PLANNING BOARD

Tuesday, December 12, 2023 at 4:30 PM
Hybrid Meeting, Room 24 (Basement Level of
City Hall) and Zoom

AGENDA:

1 NORTH ELEVATION (CRESCENT STREET FRONTAGE)
1/8" = 1'-0"

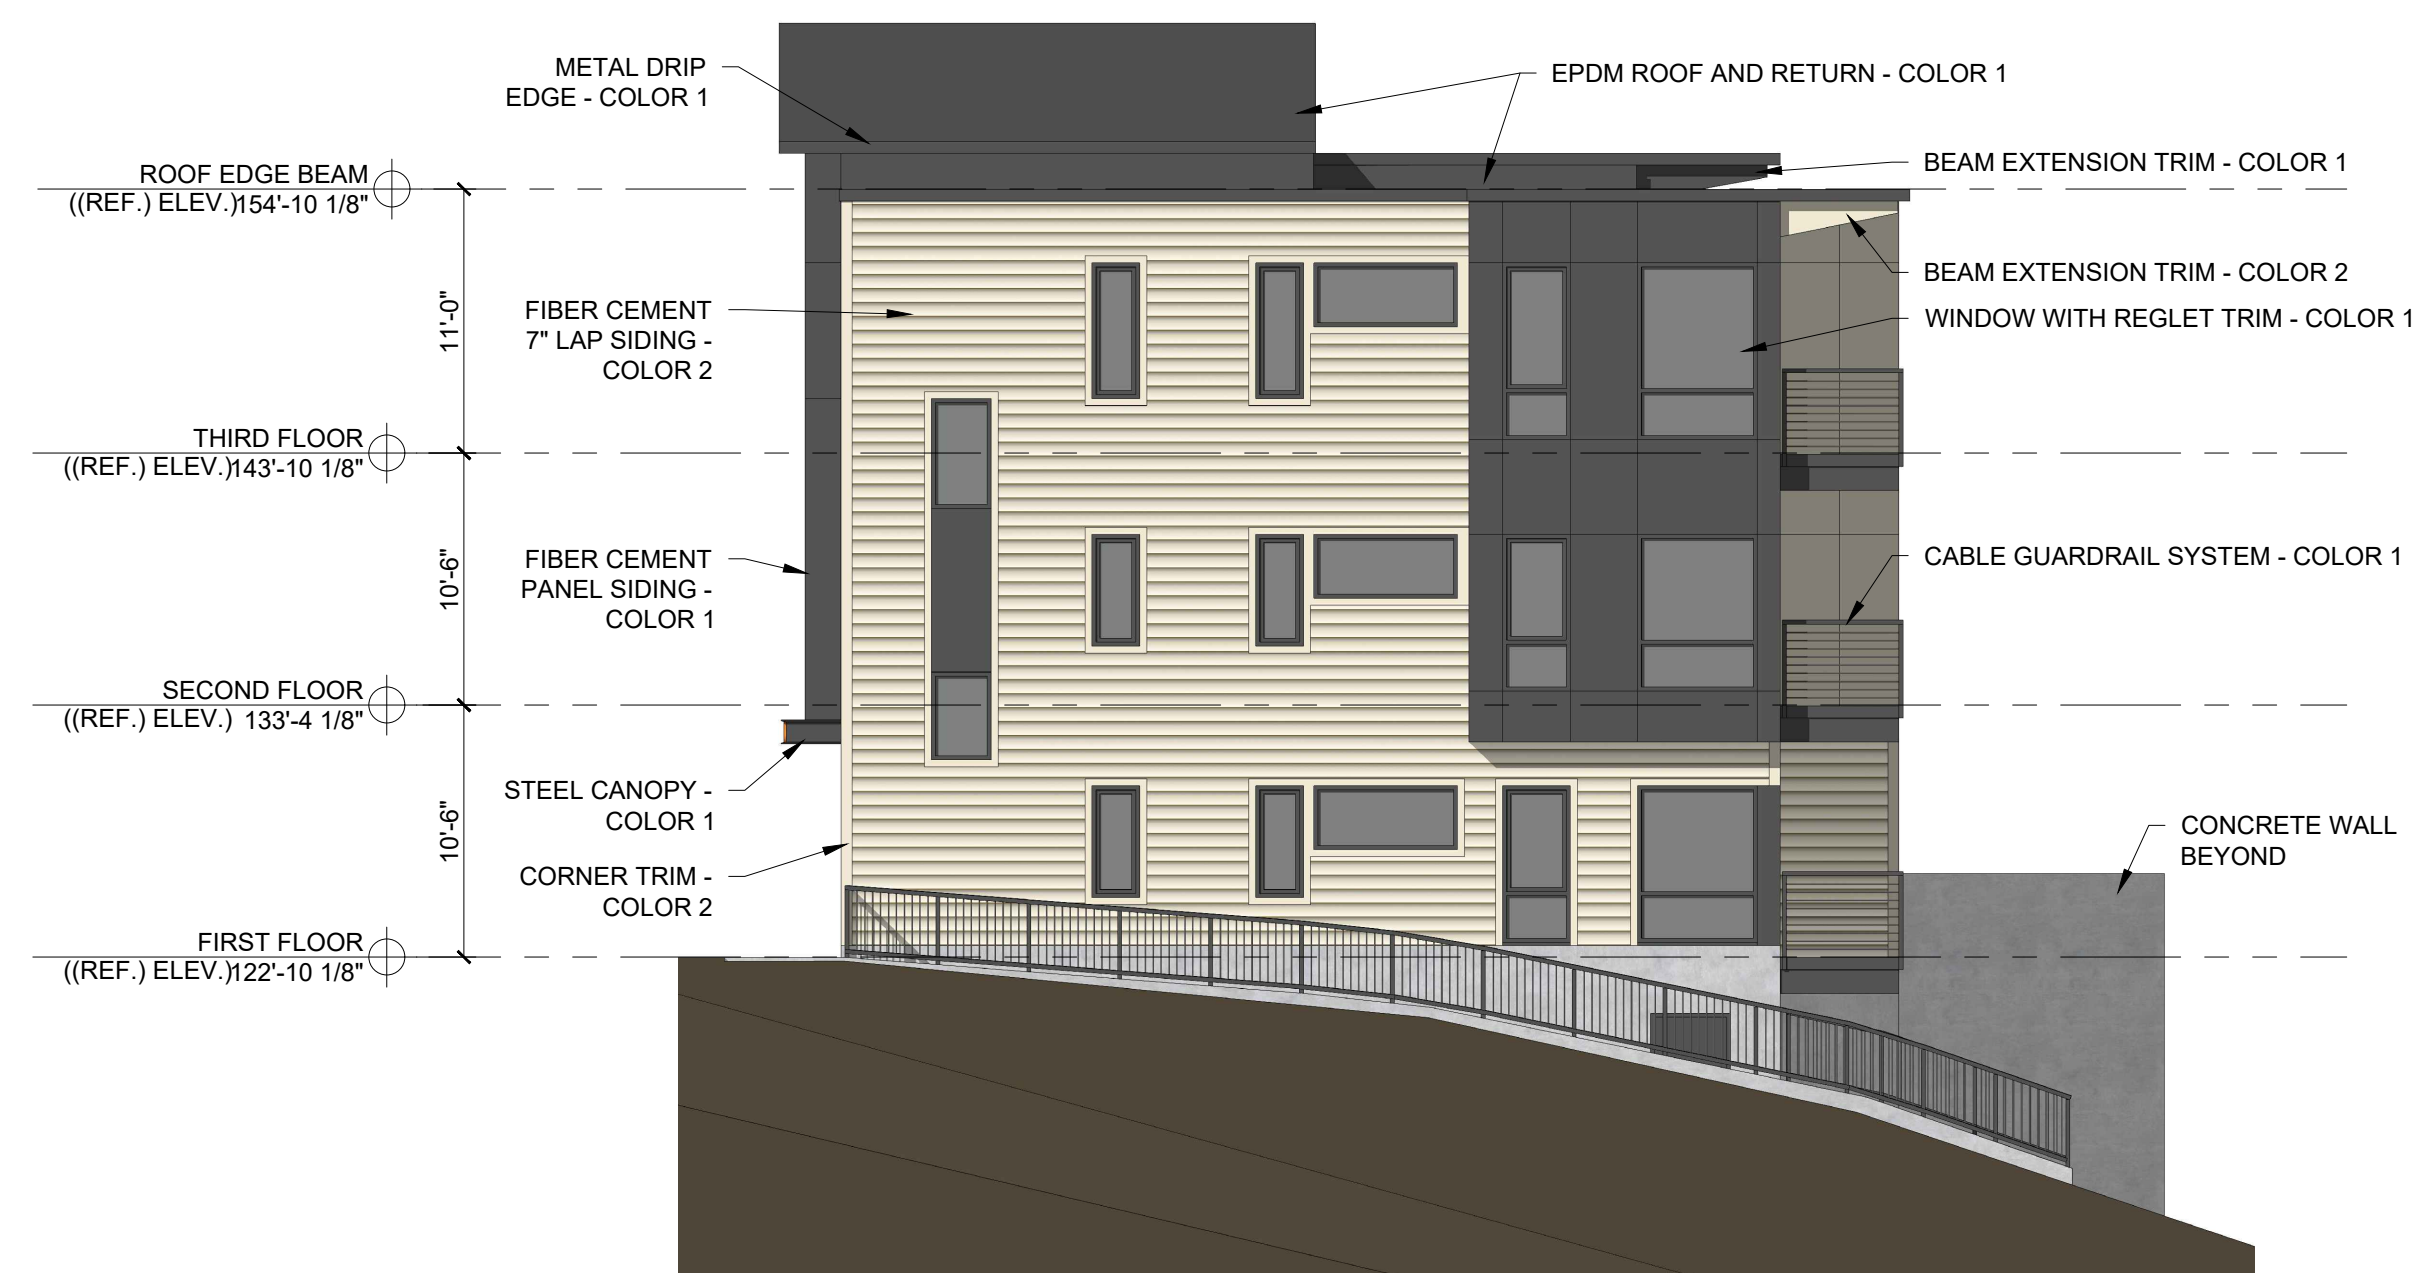
- Please provide an accurate measurement of the site's grade, calculated from all 4 corners of the parcel.
- The North and East elevations appear to be showing different proposals in the rear of the site. The North elevation appears to have a stairway leading to the ground floor deck and the east elevation appears to be more in line with what is described on the C-4.0 Site plan with a stairway leading to the basement and a ramp leading to the back yard. Please clarify what is proposed

2. *The North and East elevations appear to be showing different proposals in the rear of the site. The North elevation appears to have a stairway leading to the ground floor deck and the east elevation appears to be more in line with what is described on the C-4.0 Site plan with a stairway leading to the basement and a ramp leading to the back yard. Please clarify what is proposed.*

AVERAGE GRADE CALCULATION

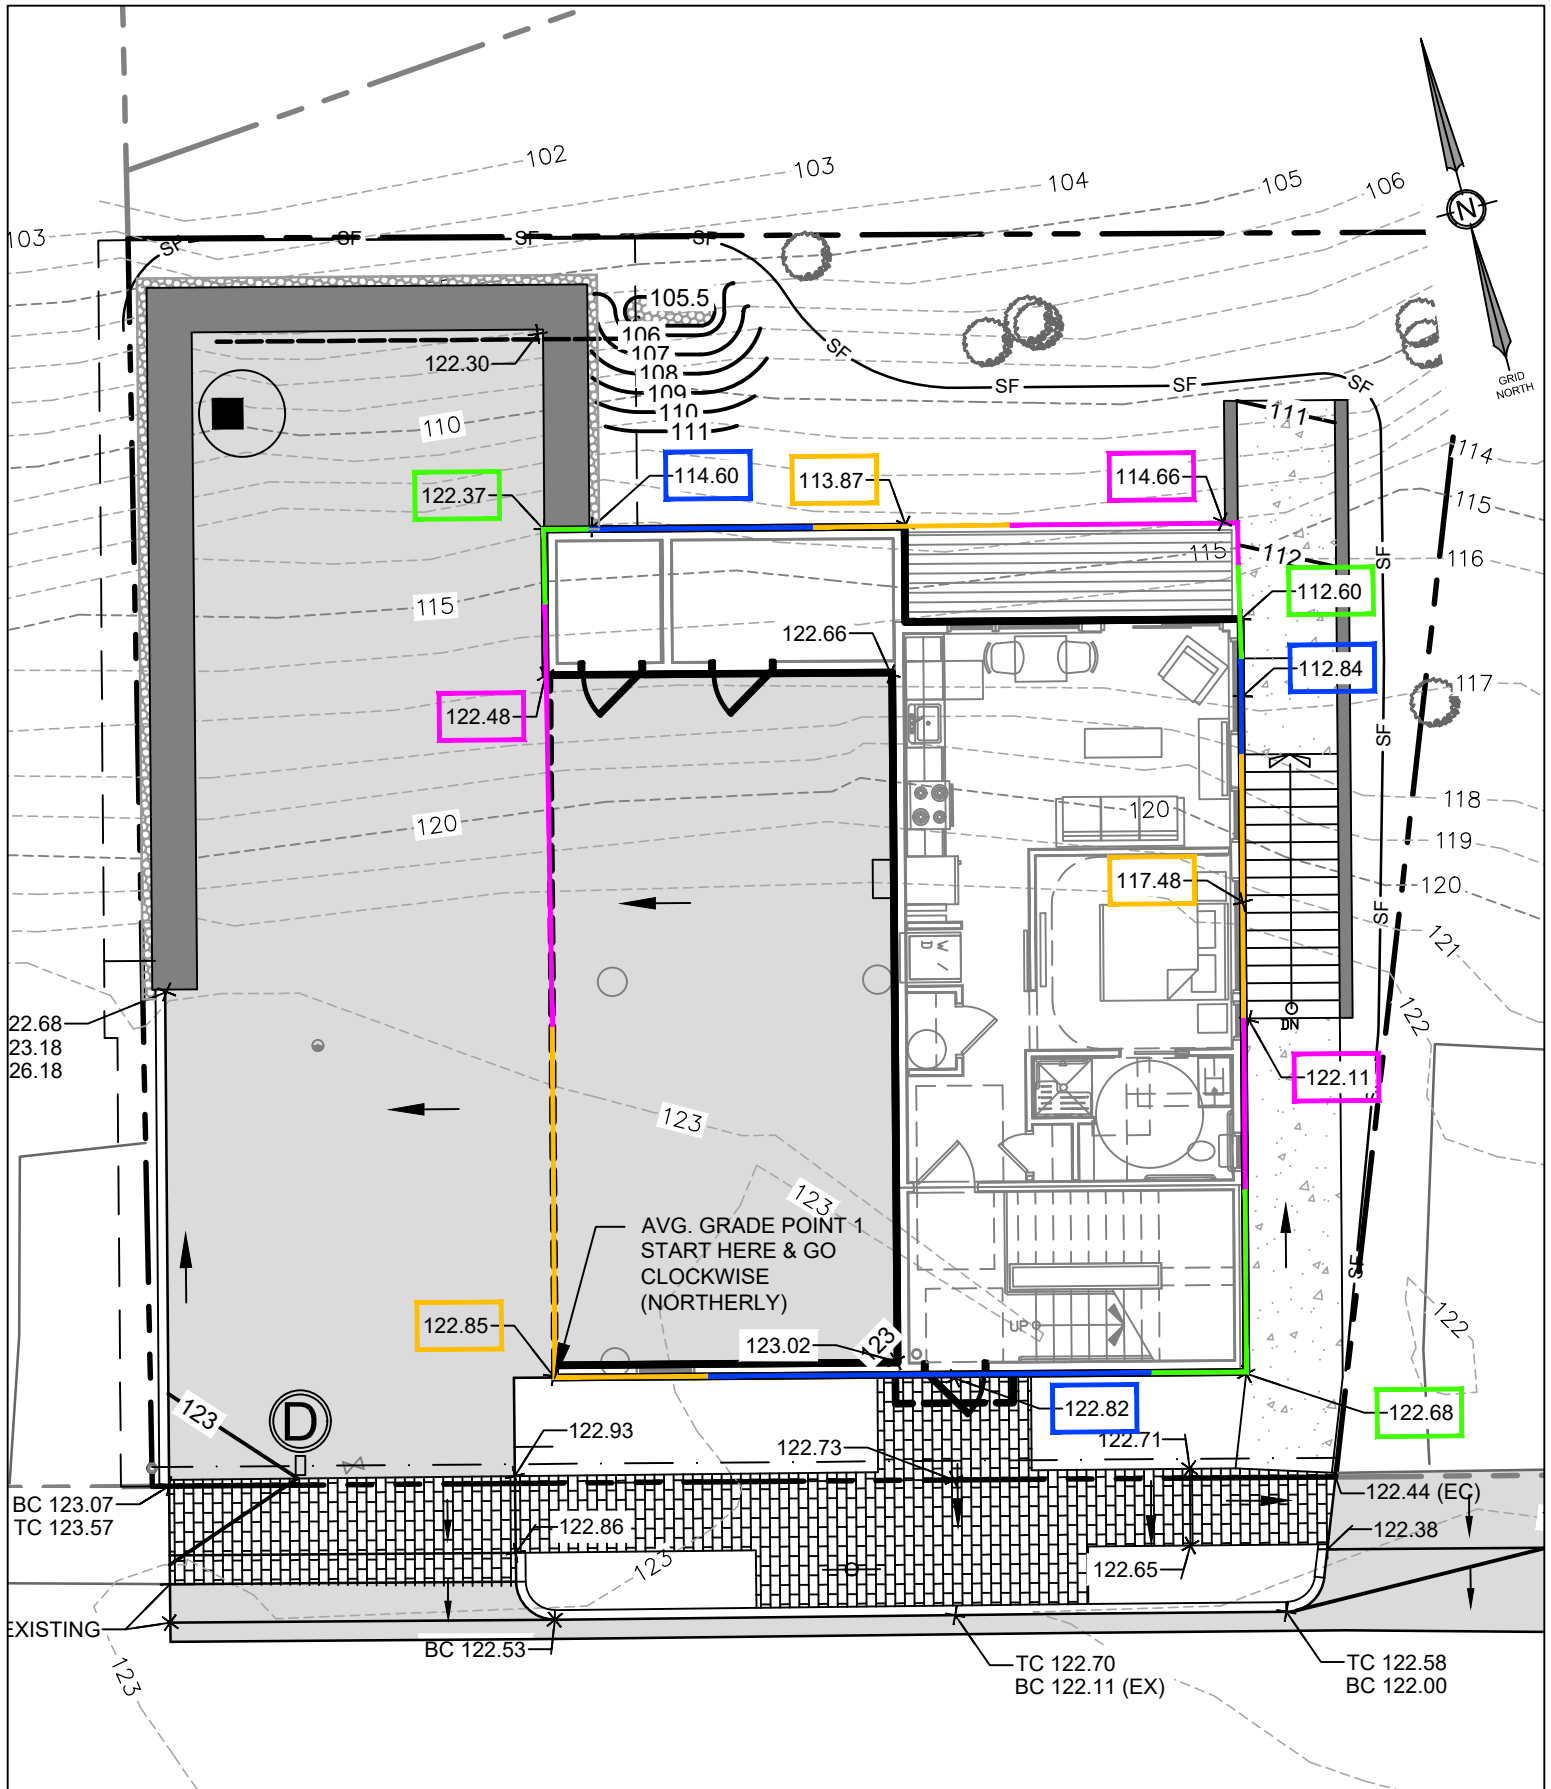
- 1. The following four points were provided for the proposed grade at the four building corners - 122.37, 122.825, 122.68 and 112.6. The first point 122.37 os not accurate. This appears to be the grade where the top of the retaining wall for the parking spaces meets the rear left corner of the proposed building. The elevation at grade for the rear left corner of the building is shown as 112.50 on plan c-5.0. If you add up the four points using this elevation the average grade is 117.66' (470.63/4).*

The proposed weighted average grade was calculated to be **119.75'**. This allows for a 35' building height reaching elevation 154.75' before requiring a stepback. The proposed building height is at 154.18' to top of roof beam, resulting in a building height of 34.43'.

DATE: 02.14.2023
SCALE: 1" = 5'
DESIGNED: AM
JOB NO: 1948
FILE: 1948-L.DWG
SHEET L-1.0

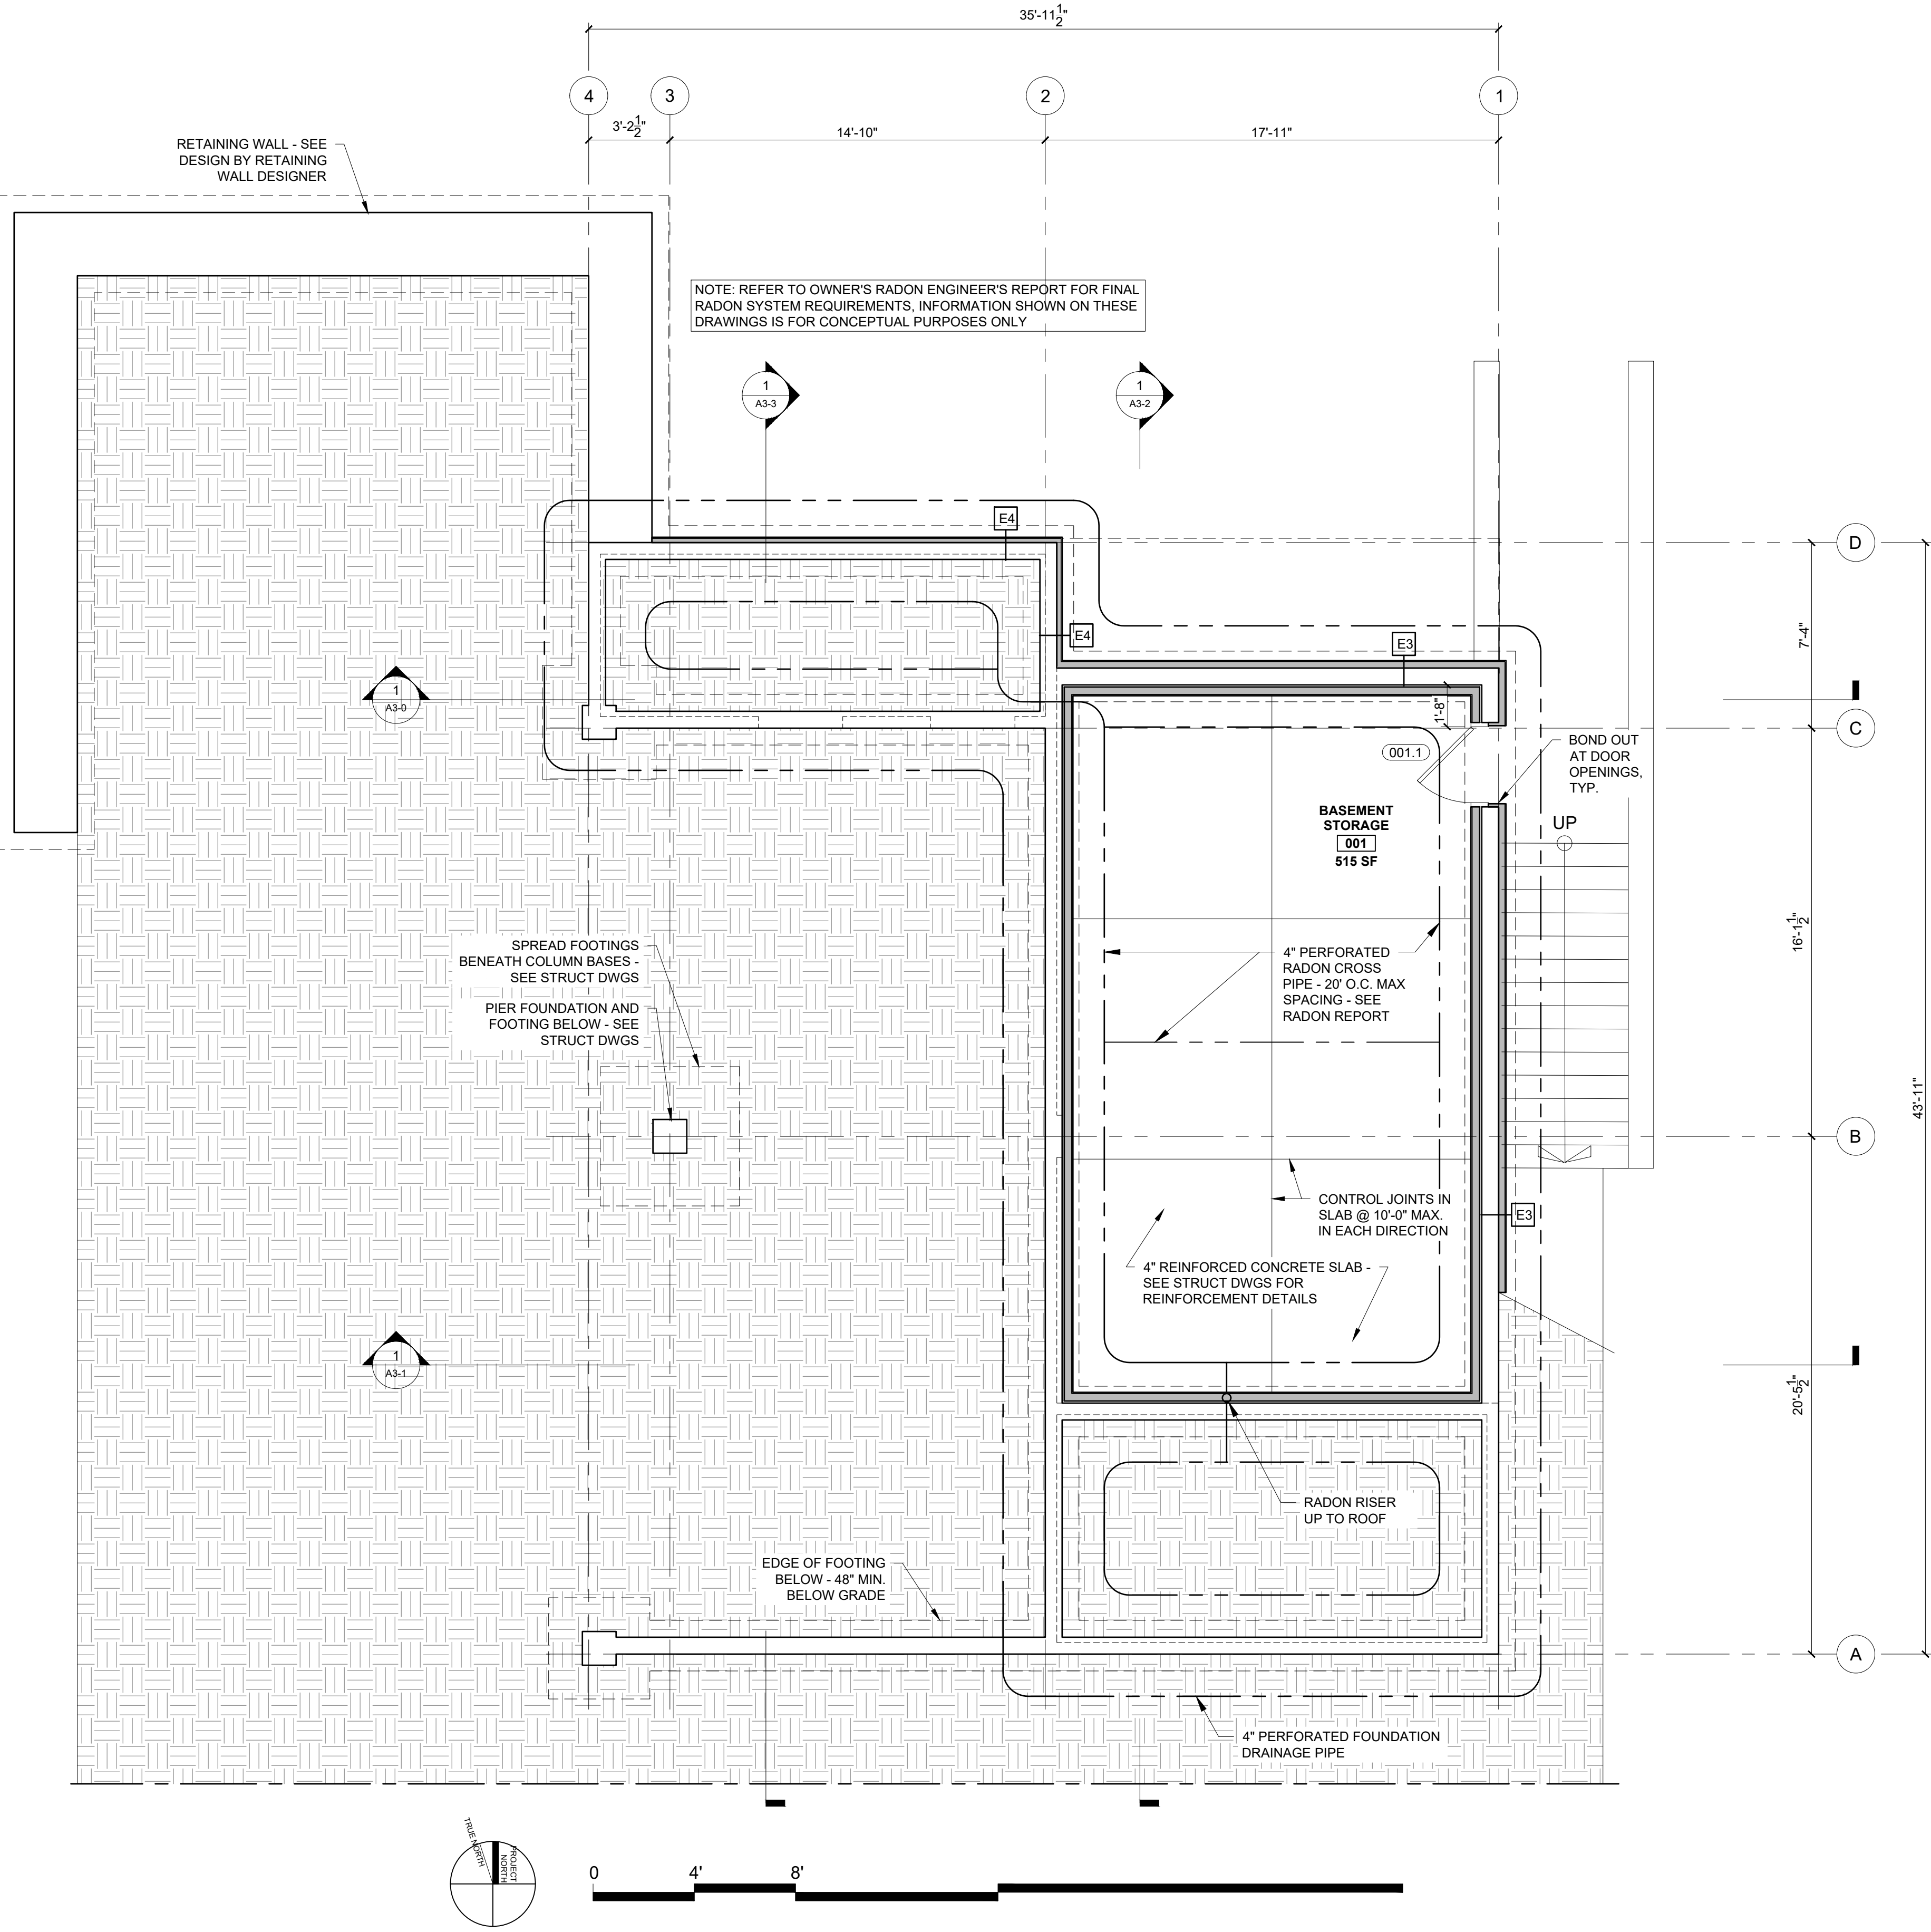
- 1. The Applicant shows two street tree wells in site plan without specific species information. Please update with proposed tree species, but take note that due to over planting the city is discouraging maple species to promote more biodiversity and resilience to the tree canopy. Section 4, figure IV 1 in technical manual provides some examples of compliant / recommended cultivars (with the exception of listed maple species, due to over planting mentioned previously.)*

Response: The landscape architect has selected European hornbeam as the street trees, which are shown on the new landscape plan L-1.0 for the project.
